SOUTHEAST SIGN CO.
ELECTRICAL SIGN AND LIGHTING SPECIALISTS
3375 NW 55th St. • Suite B • Ft. Lauderdale, FL 33309
954-332-2263

LOTIS
WELLINGTON, FL

FILE: LOT_WEL_MSP_R20_CHANGES
PATH: O:\Client Files\Lotis\Design\MSP\

#1
A.1 Newly Proposed Entry Feature w/ Signage
1/4" = 1'-0"

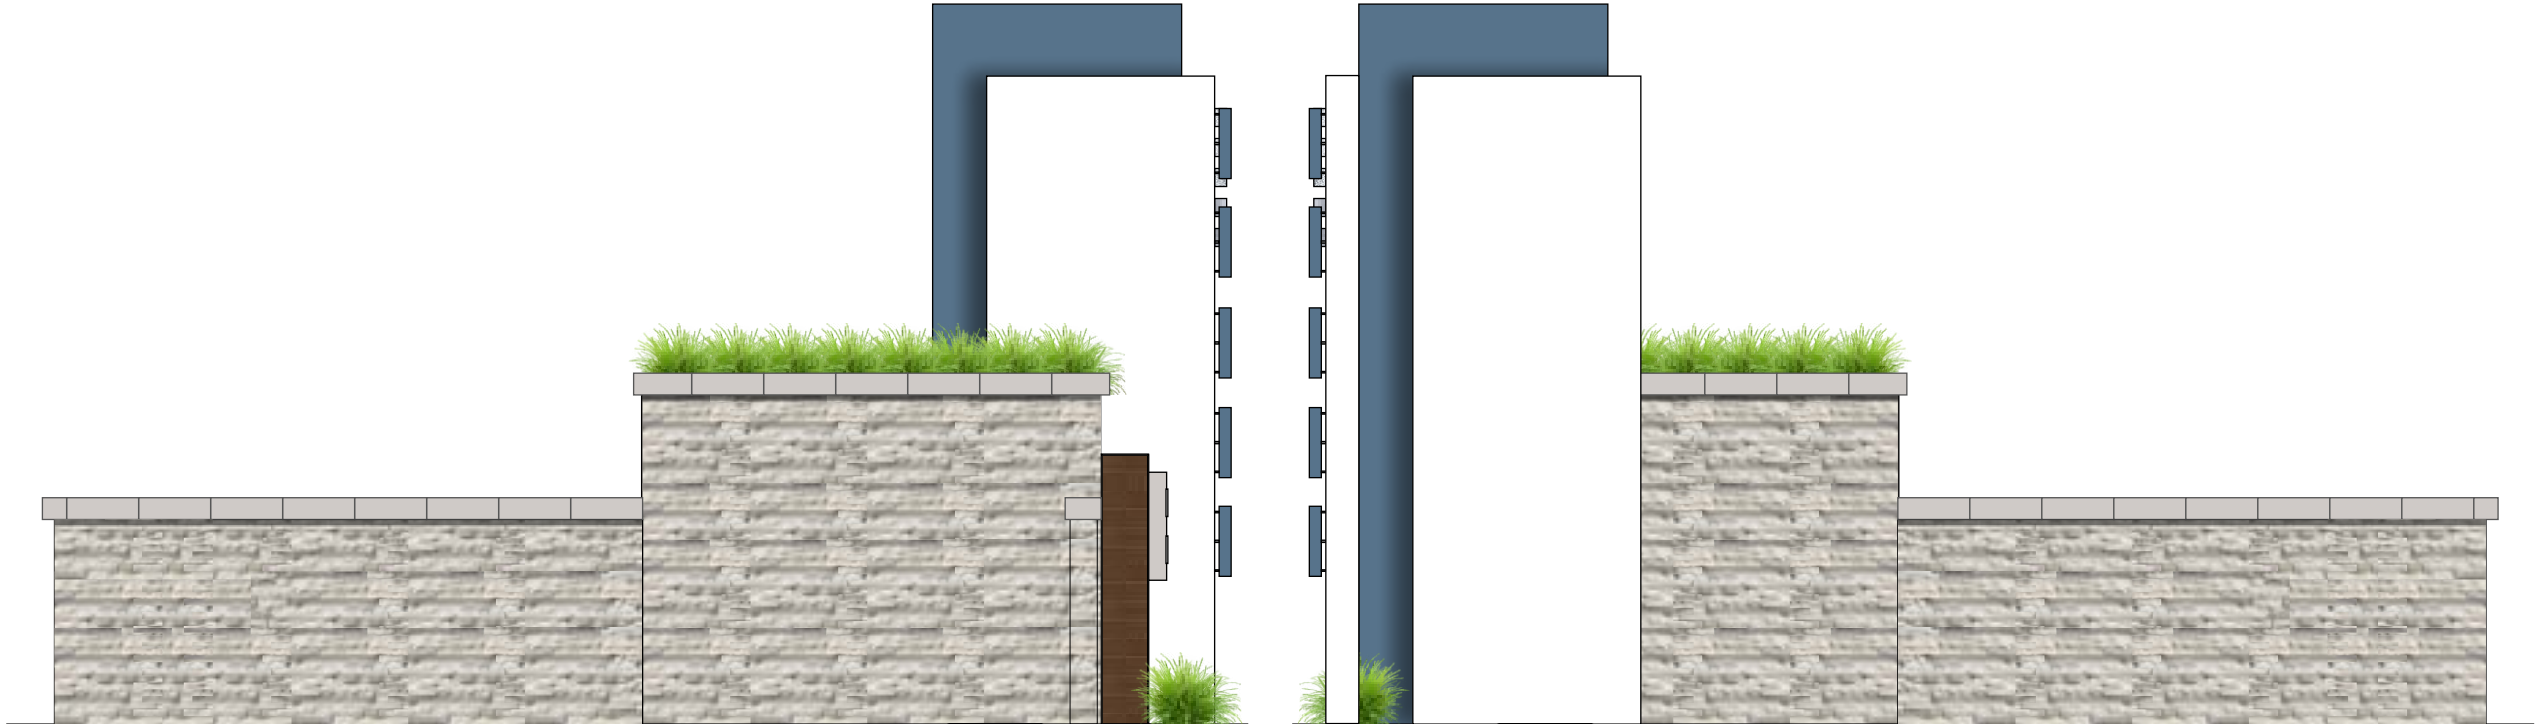
Newly proposed changes:
-Reduced short wall width, added step-down on both sides.
-Reduced quantity of tenant panels on wall.
-Added 'LOTIS' channel letters to side of entry feature for easy identification of site.
-Landscaping to include palm trees behind entry feature.

Newly Proposed Entry Feature w/ Signage
1/4" = 1'-0"

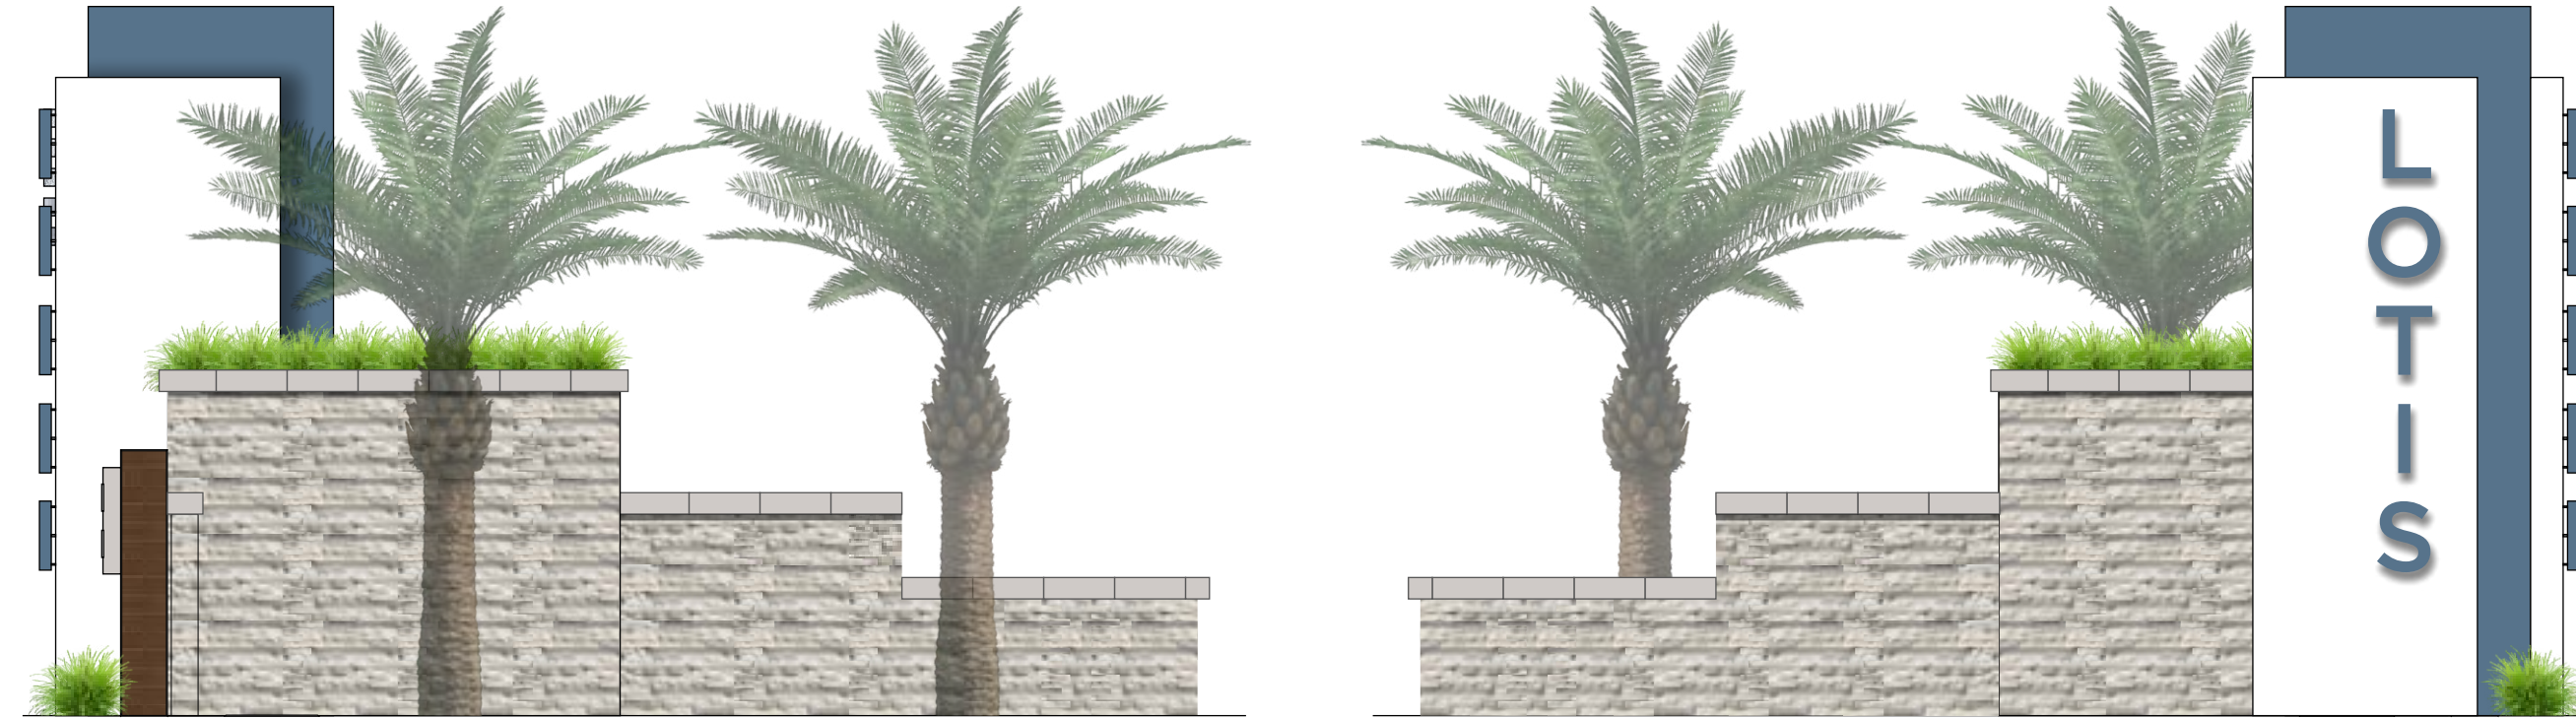
Newly proposed changes:
-Reduced short wall width, added step-down on both sides.
-Reduced quantity of tenant panels on wall.
-Added 'LOTIS' channel letters to side of entry feature for easy identification of site.
-Landscaping to include palm trees behind entry feature.

#3 B.1 Previously Proposed Multi-Panel Monument
3/8" = 1'-0" TOTAL SQ. FT.: 85.65

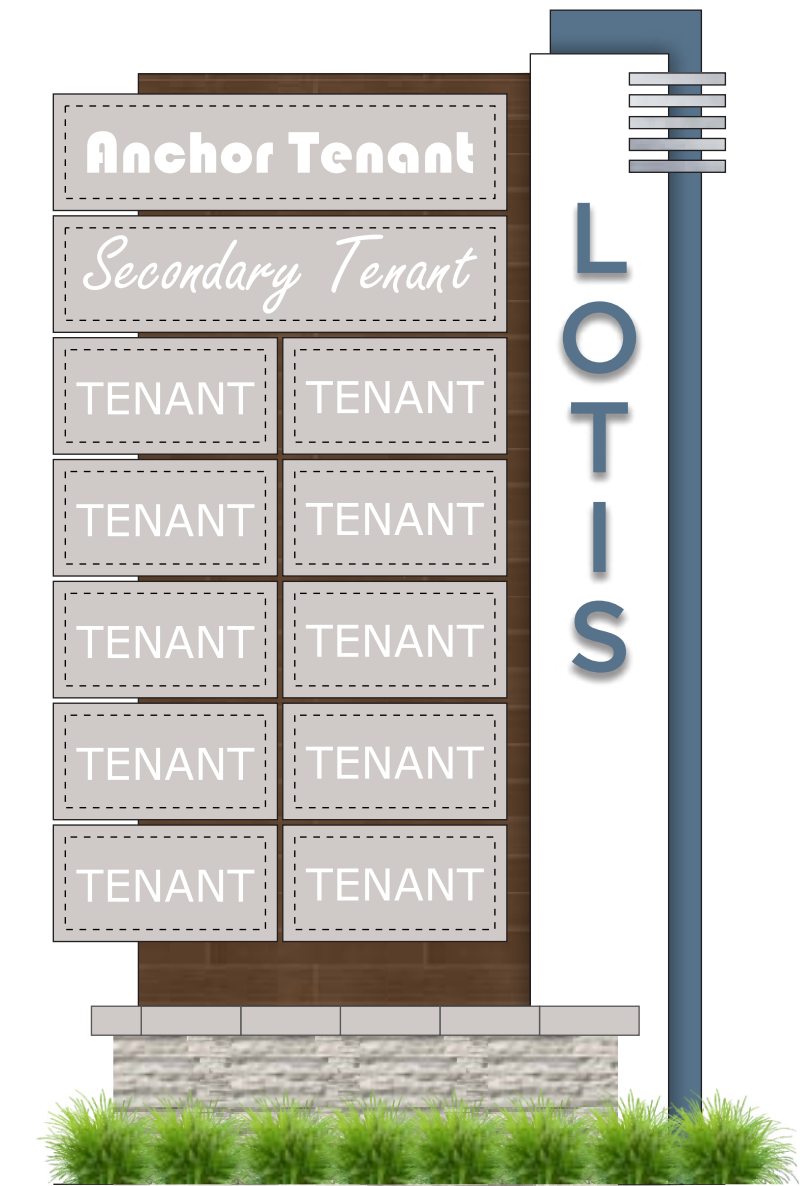
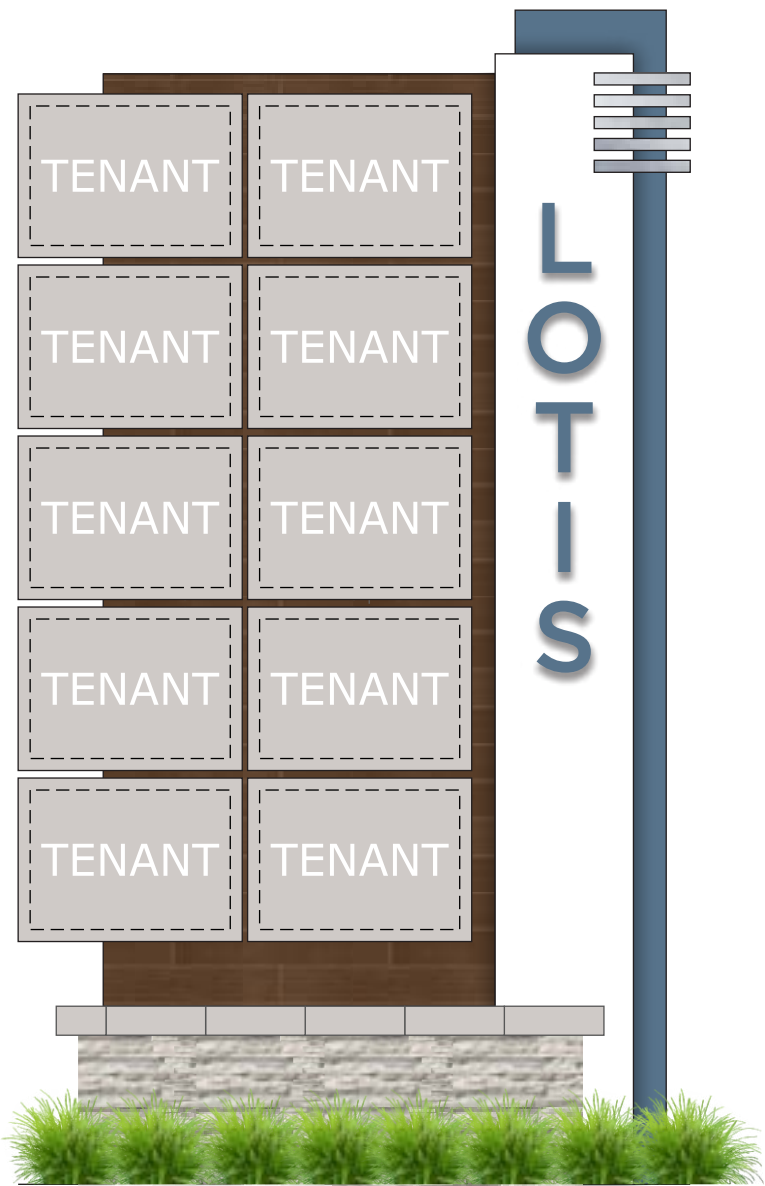
Newly proposed changes:
-Reduced Number of Tenant Panels from 12 to 10.
-Square Footage remains the same.
